Tender Number:	IFB-FQ18102/KKB
Date of Issuance:	May 11, 2018
Tender Due Date:	May 16, 2018
Revised Tender Opening Date:	May 23, 2018

**AMENDMENT NO. 02
TO
INVITATION FOR BIDS
FOR**

Replacement of Chiller and Cooling Tower Accessories at Eight (8) Metro-rail Stations:
DC, MD, and VA
IFB-FQ18102/KKB

AIR SYSTEM - CHILLER ROOM FLOOR PLAN - NEW WORK

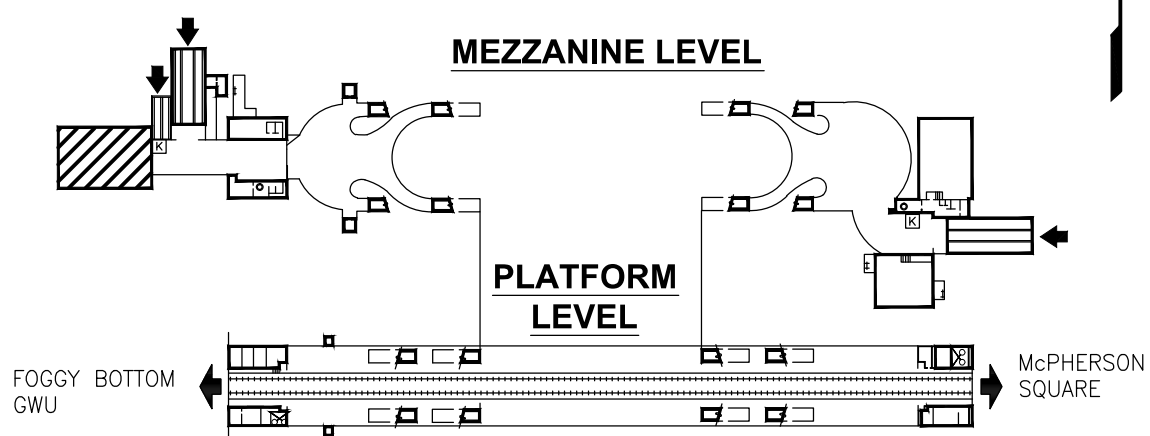
<u>DELETE</u>	<u>SUBSTITUTE</u>	<u>DESCRIPTION</u>
Drawing Nos. CWPC03-M-103-Farragut West, CWPE05-M-101-Georgia Ave-Petworth, And CWPB11-M-101-Glenmont	Drawing Nos. CWPC03-M-103 - Farragut West, CWPE05-M-101 - Georgia Ave-Petworth, and CWPB11-M-101- Glenmont, Amendment No. 02	Revised to include Horns & Strobes

- 5 PROVIDE AND INSTALL NEW REFRIGERANT LEAK MONITORING AND CONTROL SYSTEM, INCLUDING TUBING, SENSORS, STROBE LIGHTS, AND ALARM. INTEGRATE WITH NEW EXHAUST FAN EF-7. INTEGRATE WITH CHILLER PLANT MONITORING PANEL. REFRIGERANT DETECTION SYSTEM SHALL UTILIZE SHERLOCK 402-4 CONTROL MODULE AND SHERLOCK REFRIGERANT GAS SENSOR FOR R134A. TWO REFRIGERANT DETECTION SENSORS SHALL BE USED AND THE PROBES SHALL BE LOCATED BELOW EACH REFRIGERANT MONITORING PANEL. CONTRACTOR SHALL FIELD VERIFY AND INSTALL SENSORS 18" ABOVE FINISHED FLOOR LEVEL. REFER TO EXHAUST FAN SEQUENCE OF OPERATION ON DRAWING CWPC03-M-610.

DYNAMIC OUTLINE DIAGRAM
TANGENT TRACK

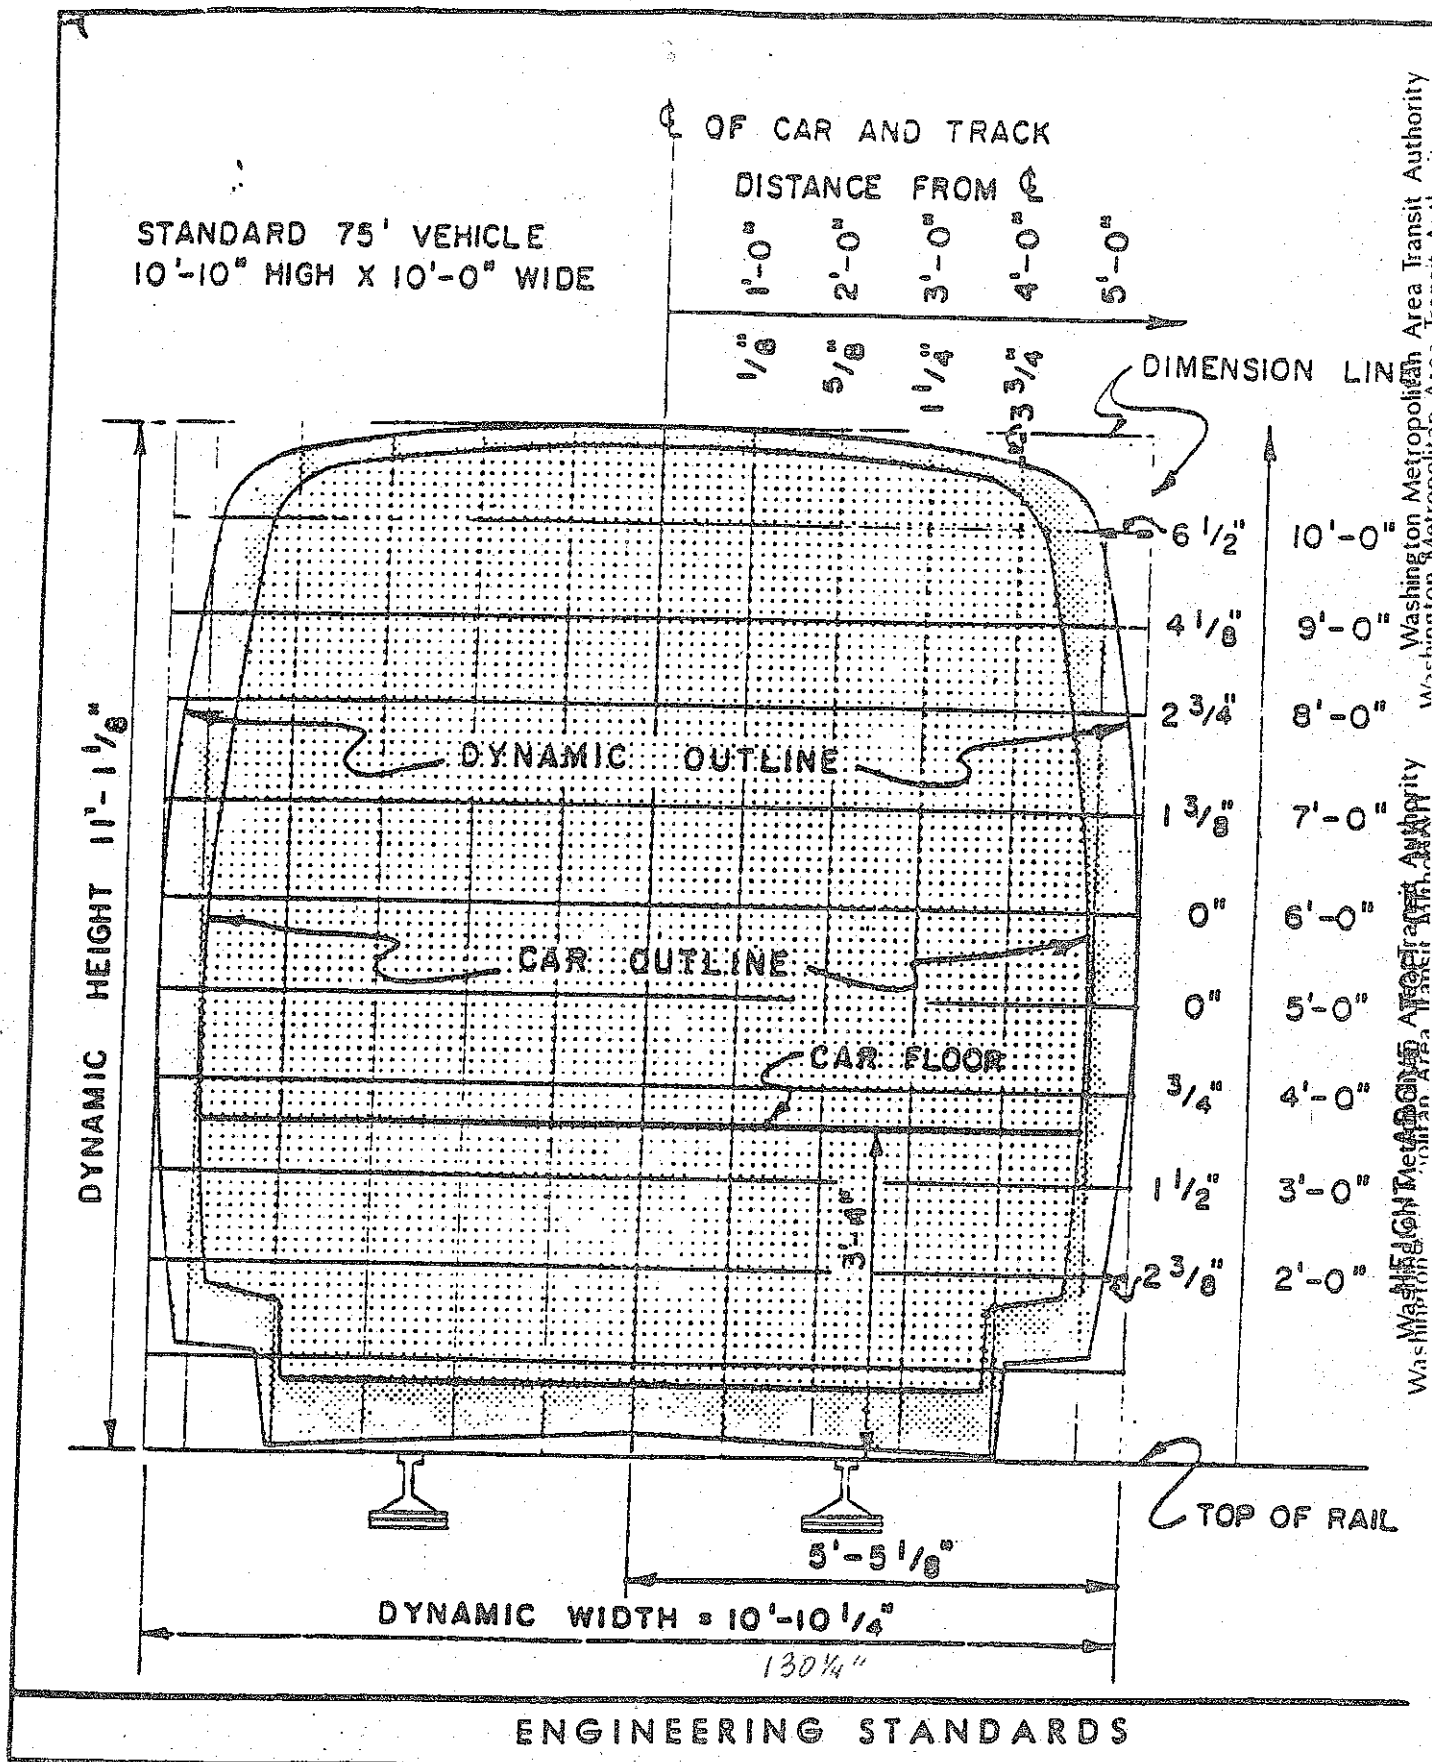
9		Please advise if it is acceptable to use the monorail and chainfall that was in place during the pre-bid walk through. This rigging equipment was located outside the chiller plant above the tunnel access panels.	The existing trolley and chain fall appears to be in great condition, but will have to be approved by SAFE before using to confirm it can handle the weight capacity of the existing and new chiller.
10		<p>Please provide the following clarification for utilizing prime movers for equipment and material.</p> <p>Please provide the dimensions of the bed of the prime mover.</p>	<p>Prime mover support must be requested 3 weeks in advance.</p> <p>The average flat car of a prime mover is 53'6" long x 10' wide x 3'6" tall from the top of the rail. See attached dynamic outline/envelope figure for bringing in equipment.</p>
